APPEAL SUMMARY

Appeal ID: 23804	Project Address: 1102 - 1116 SW Washington St
Hearing Date: 6/10/20	Appellant Name: Robert Snyder
Case No.: B-012	Appellant Phone: 503-863-2354
Appeal Type: Building	Plans Examiner/Inspector: Brian McCall
Project Type: commercial	Stories: 25 Occupancy: A-3, B, M, R-2, S-1, S-2 Construction Type: I-A
Building/Business Name: 11W	Fire Sprinklers: Yes - throughout
Appeal Involves: Erection of a new structure	LUR or Permit Application No.: 19-214942-MG
Plan Submitted Option: pdf [File 1] [File 2]	Proposed use: Mixed use: Commercial Office, Housing, Retail, and Parking

Appeal item 1

PLAN, LEVEL 08

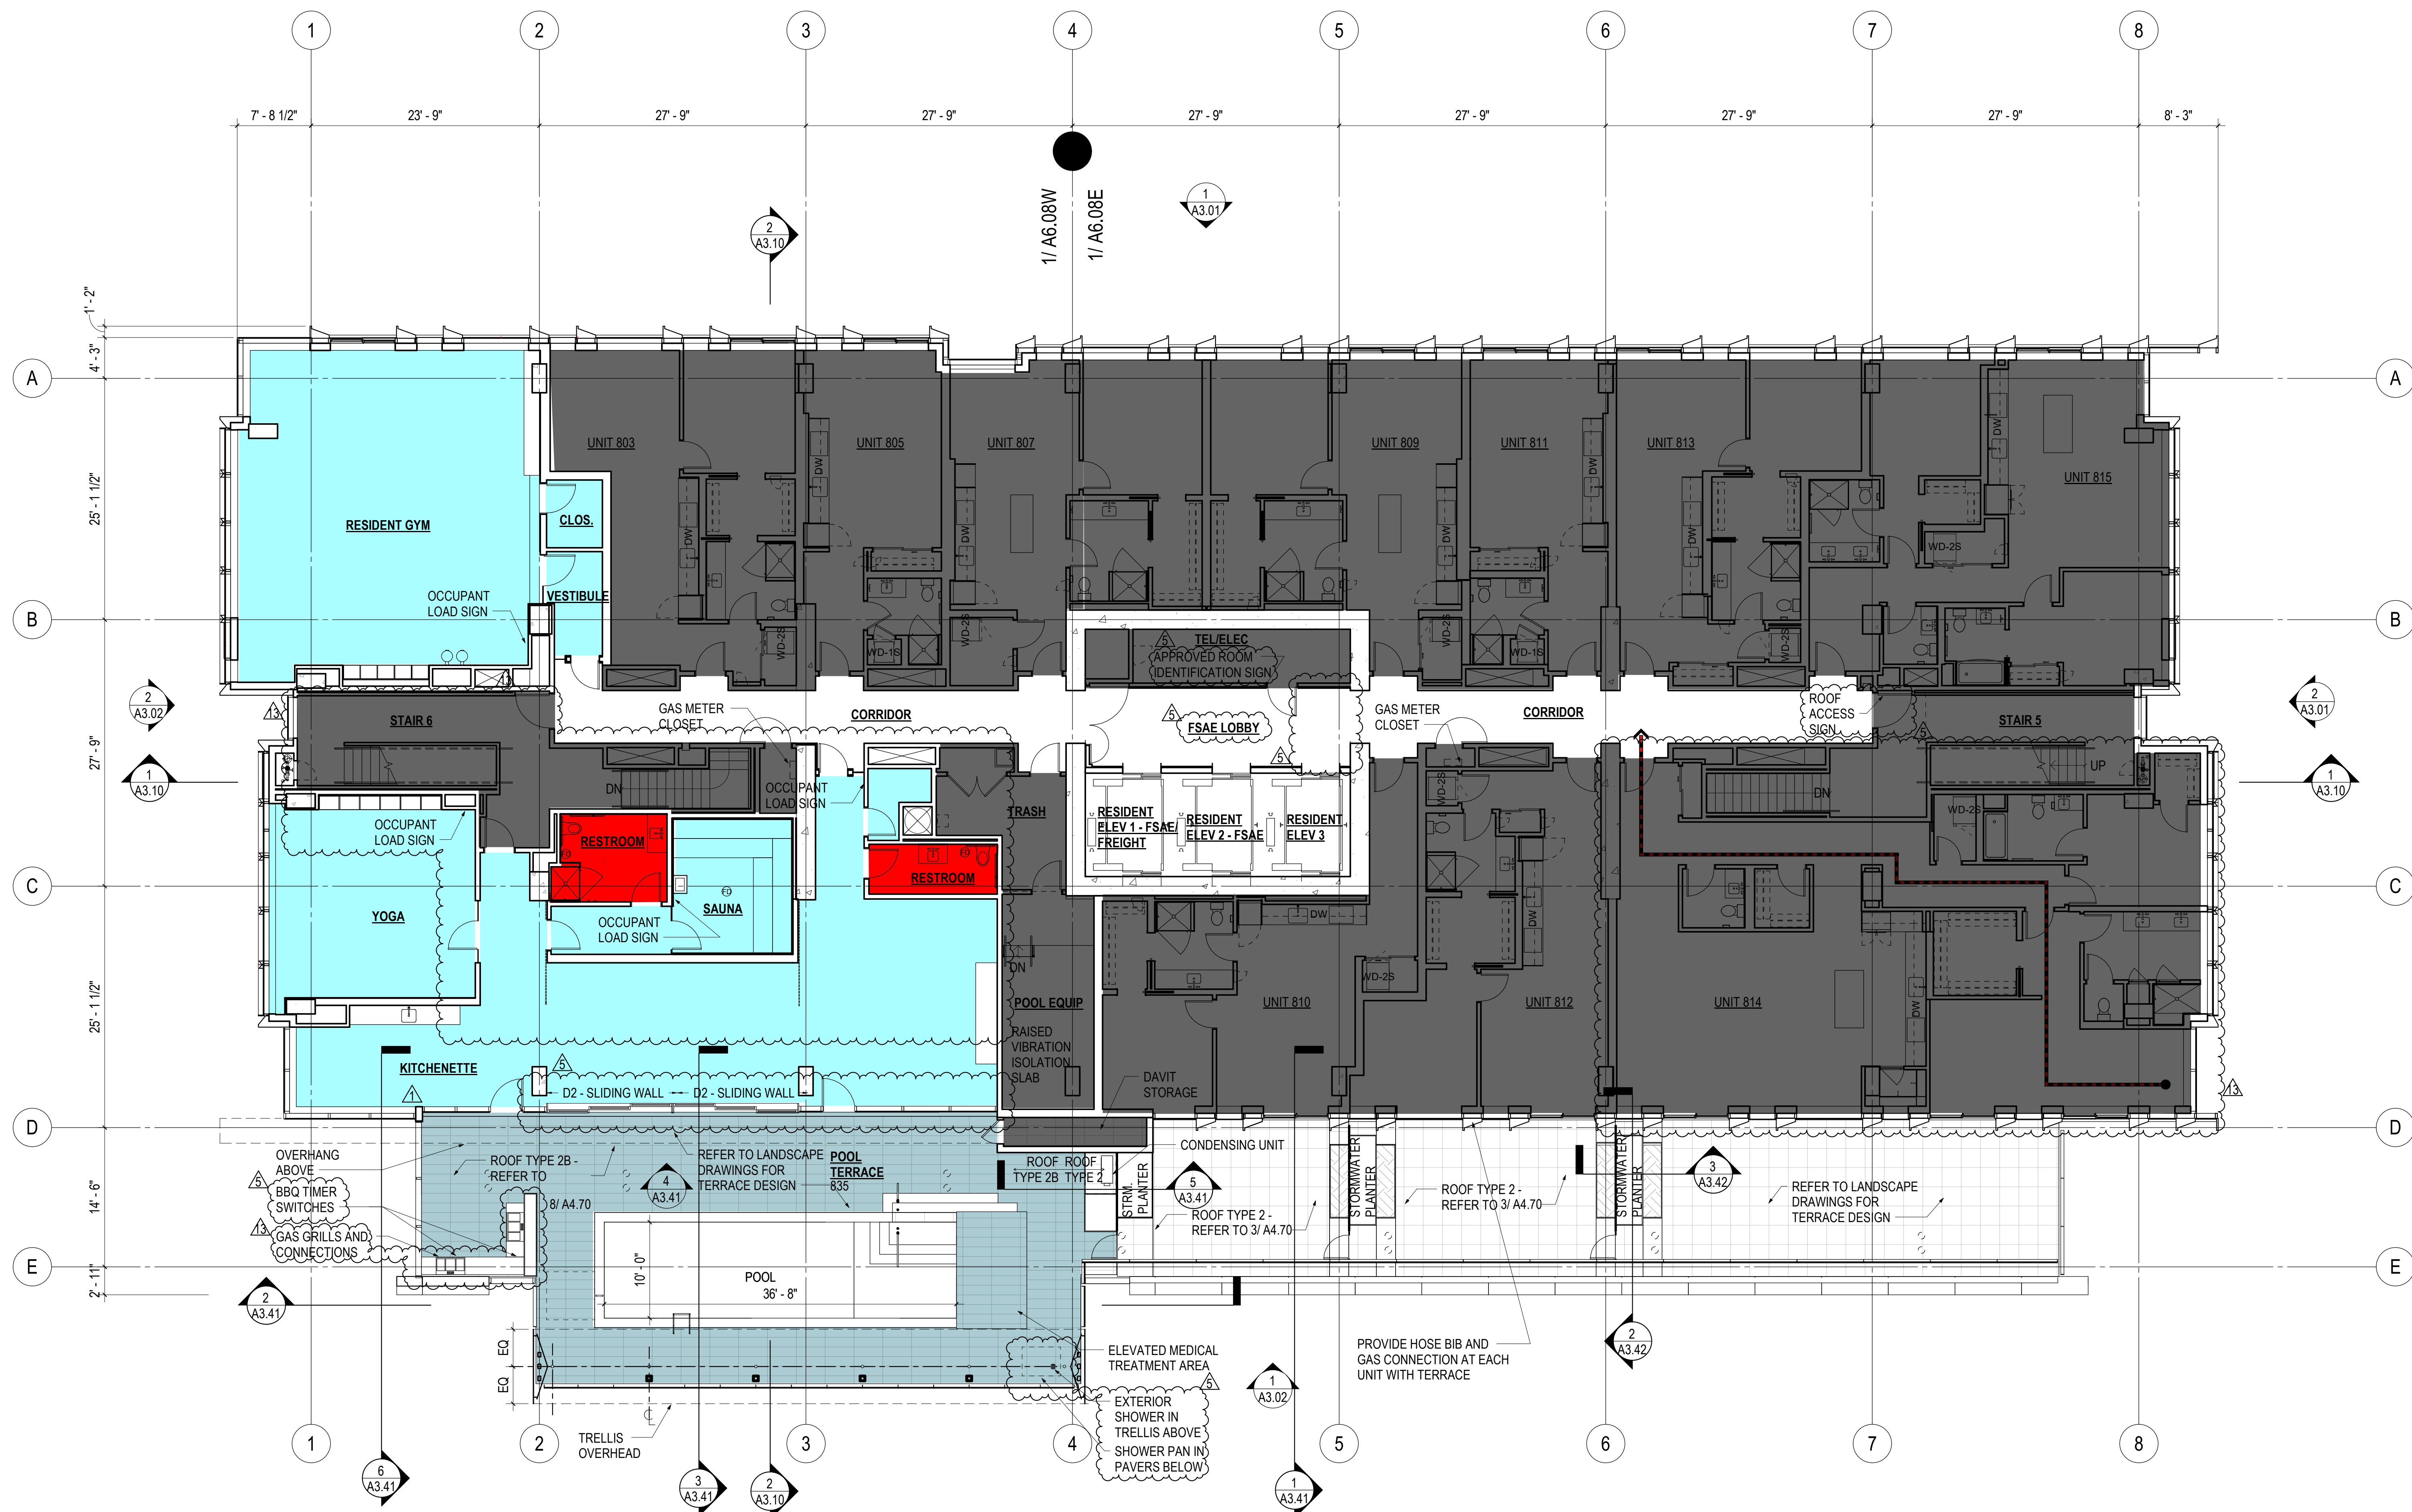
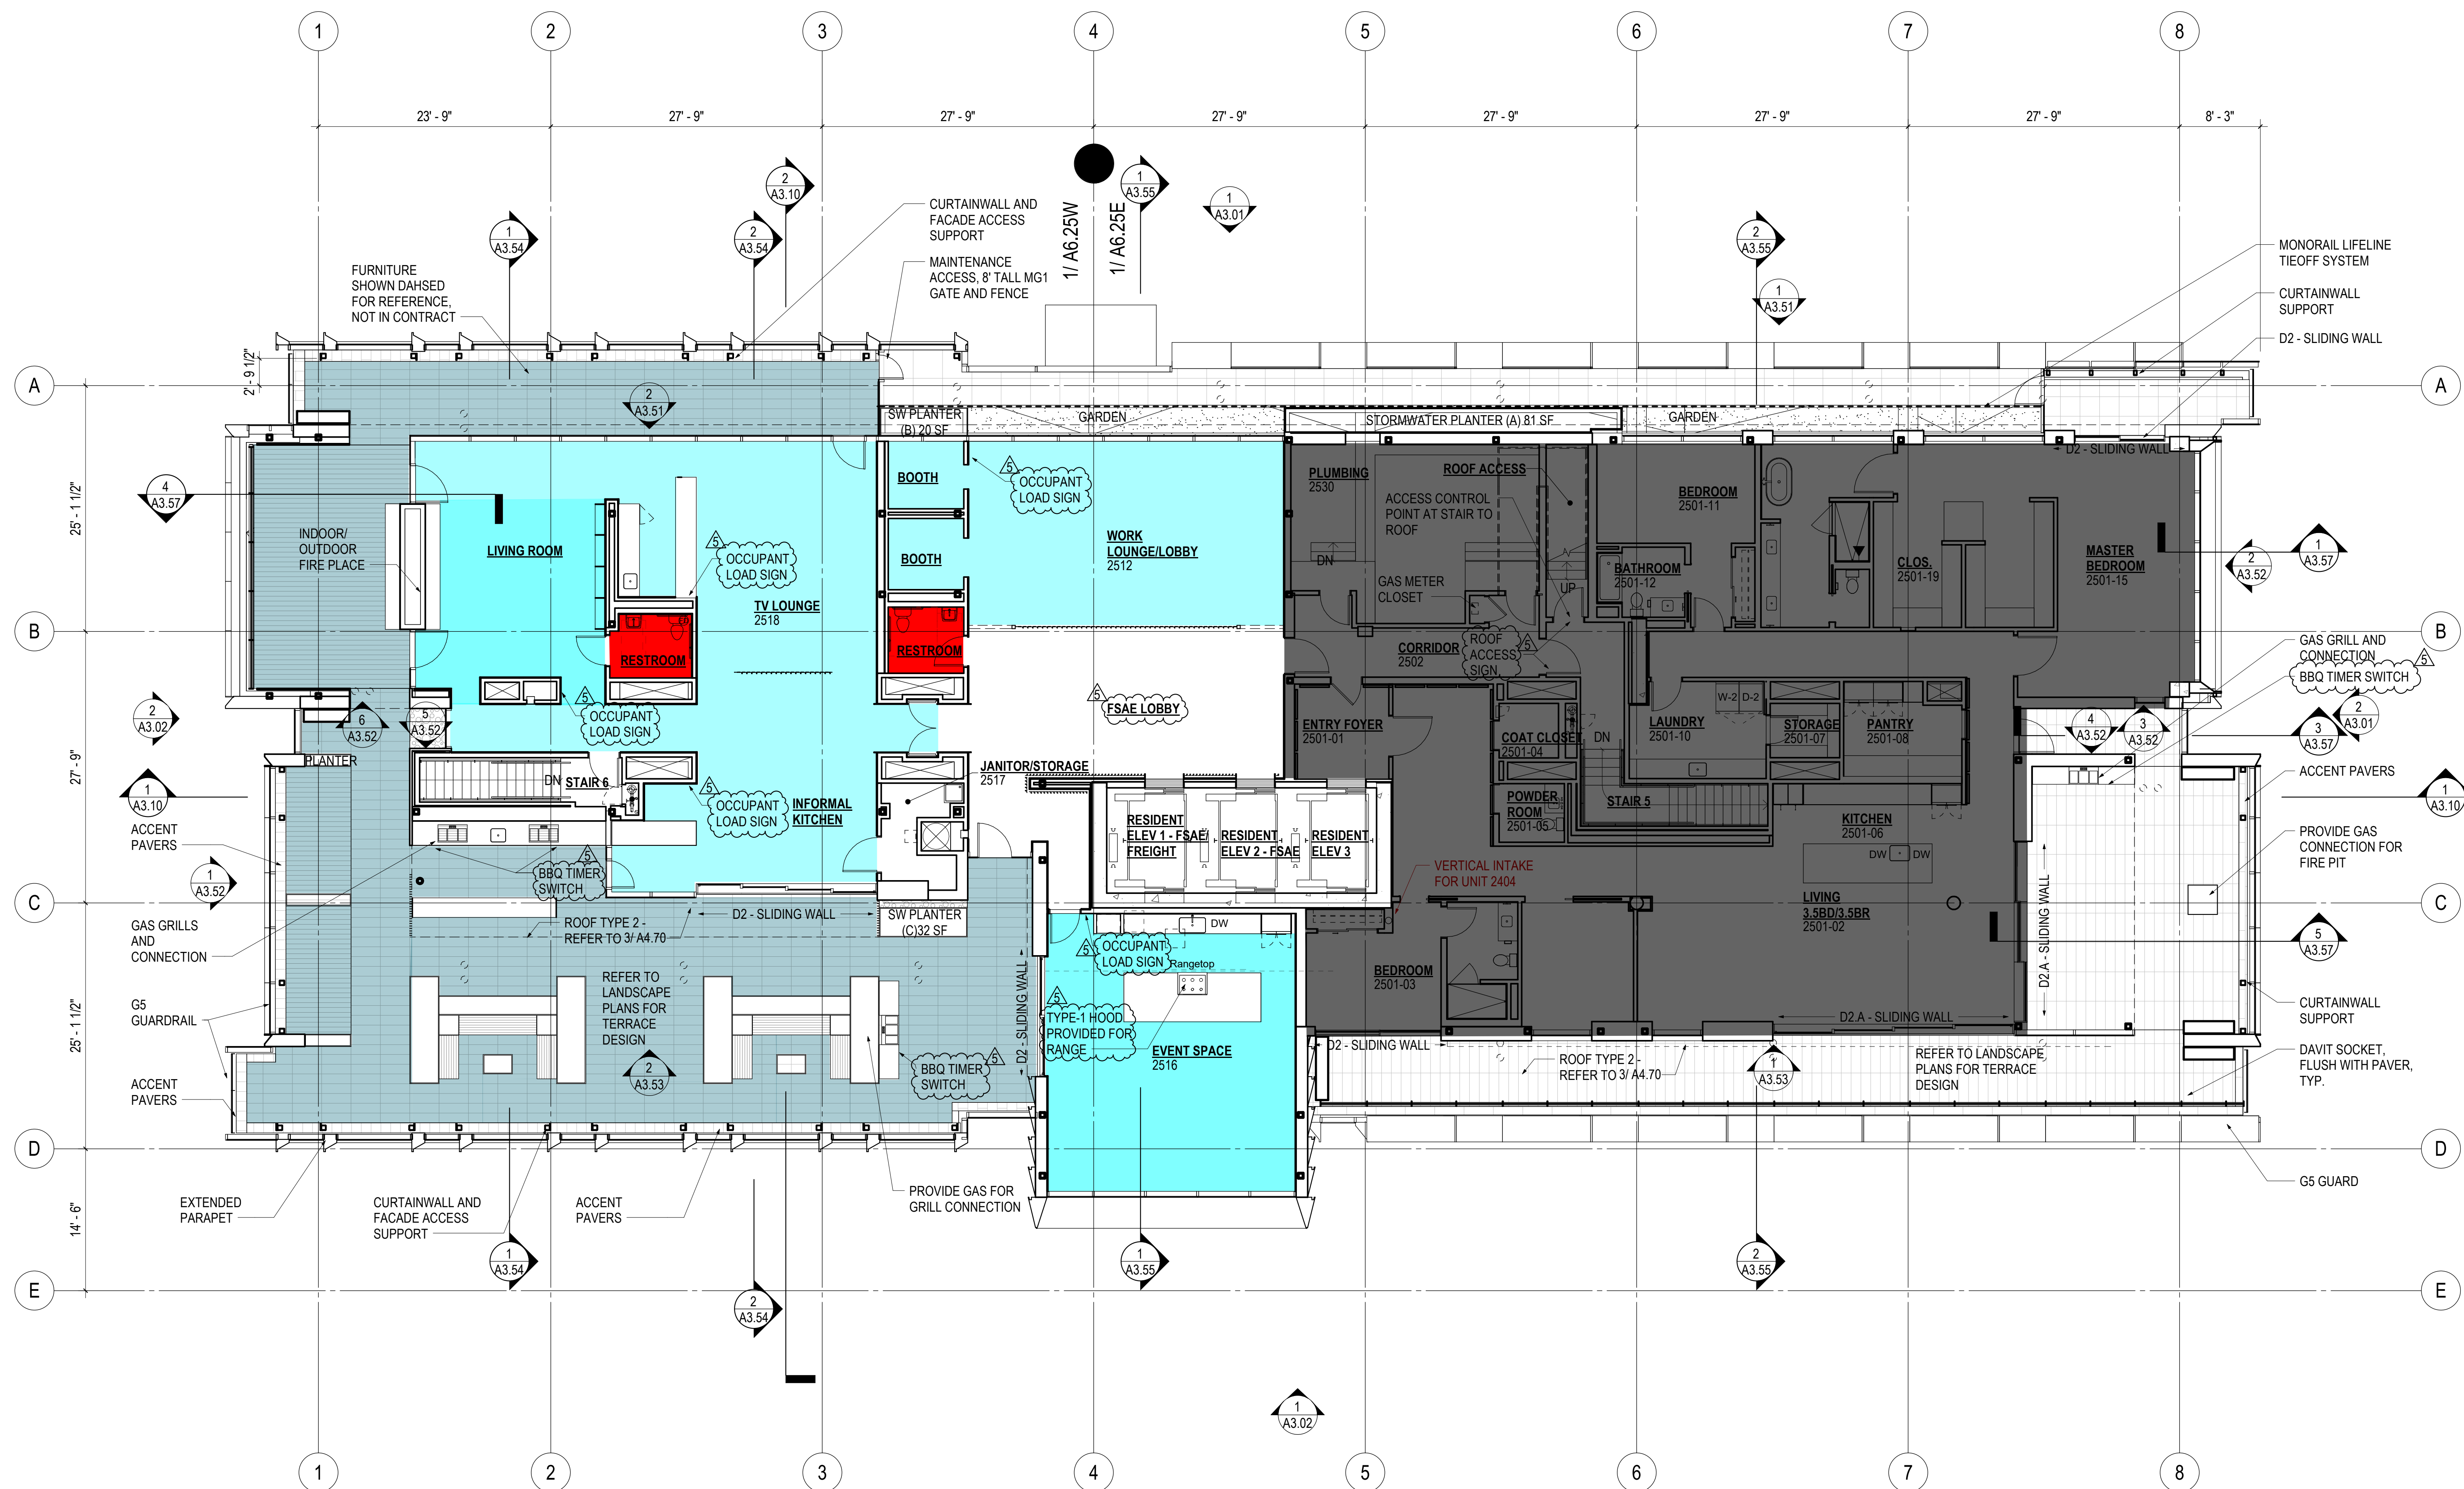
The calculated occupant load in a fully loaded condition per code for Level 08 is 301.85 occupants. 5 gender assigned fixtures are required - 2.40 women's 1.32 men's
2 toilet fixtures will be provided in a gender-neutral format.

Reason for alternative This alternate is being requested to allow less than the code required toilet fixtures for the two amenity areas of the building. The amenity areas being exclusively for tenants and their guests who will have access to facilities within their units located on or above level 8 or on or below level 25 reducing the need to convenience use.

The fixtures provided on Level 8 & Level 25 in a gender-neutral configuration ensure ready access to a restroom facility without visiting a dwelling unit should that be desired, however all users of the space will also have access to the bathrooms in their apartment units, many of which are located on the same floor, or on an adjacent floor. Therefore, we feel the design has provided equivalent accommodations meeting the intent of the code.

Reduction in the minimum required number of plumbing fixtures for tenant amenity spaces: Granted as proposed.

PLAN, LEVEL 25

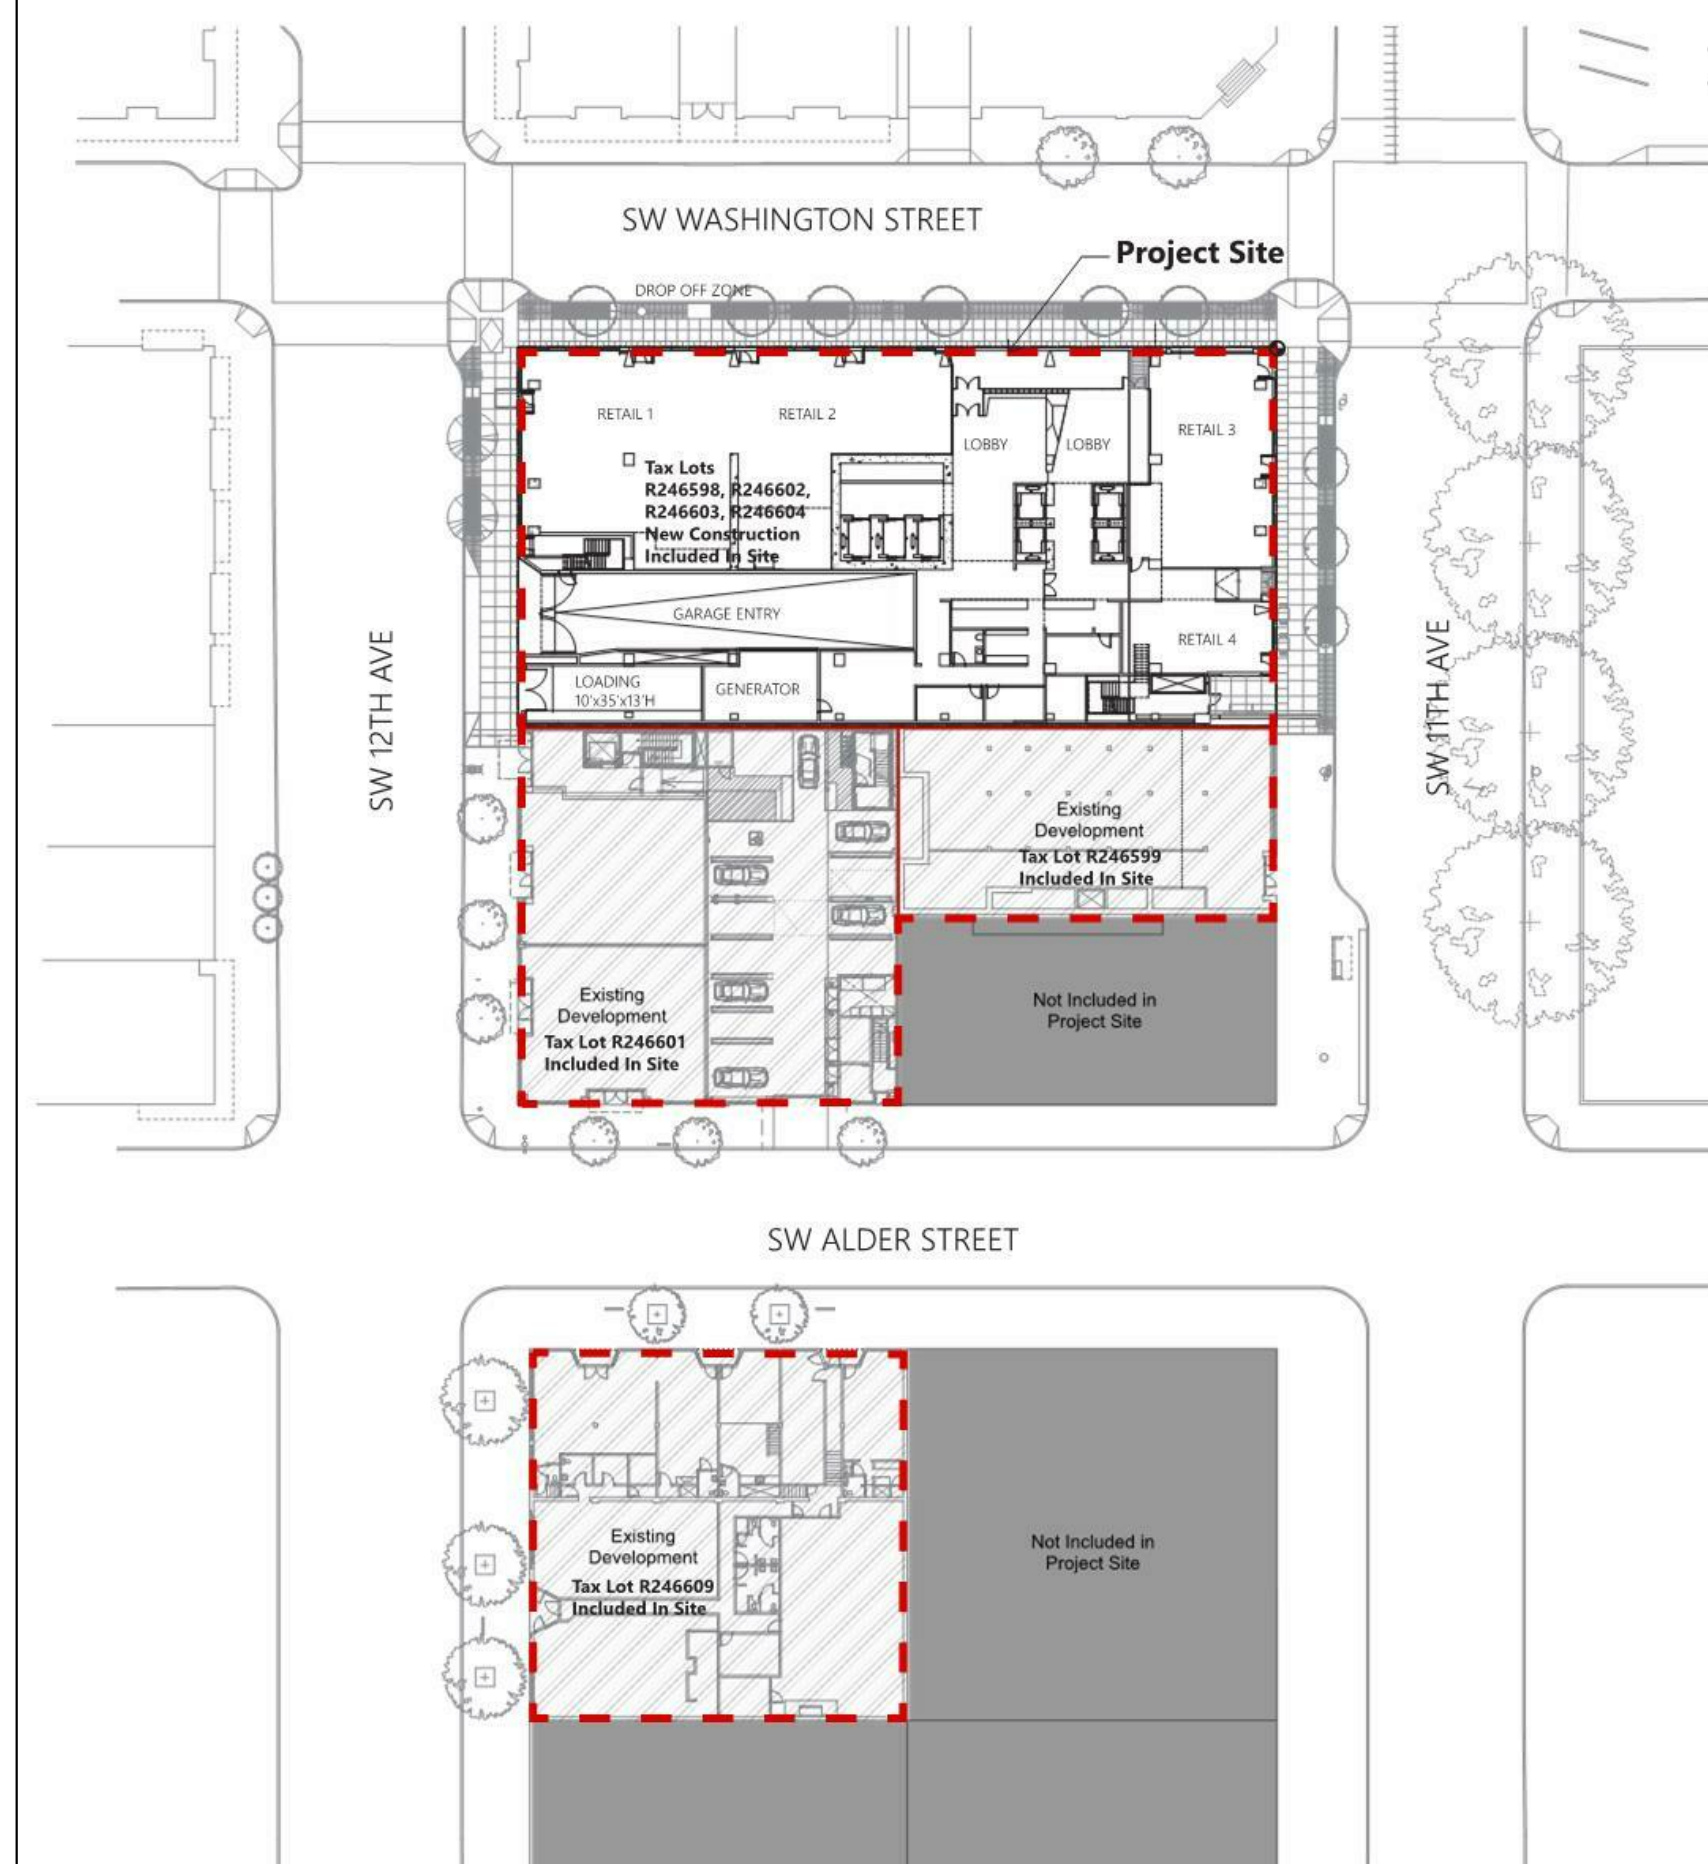
The calculated occupant load per code for Level 25 is 372.40 occupants. 5 gender assigned fixtures are required - 2.87 women's 1.50 men's
2 toilet fixtures will be provided in a gender-neutral format.
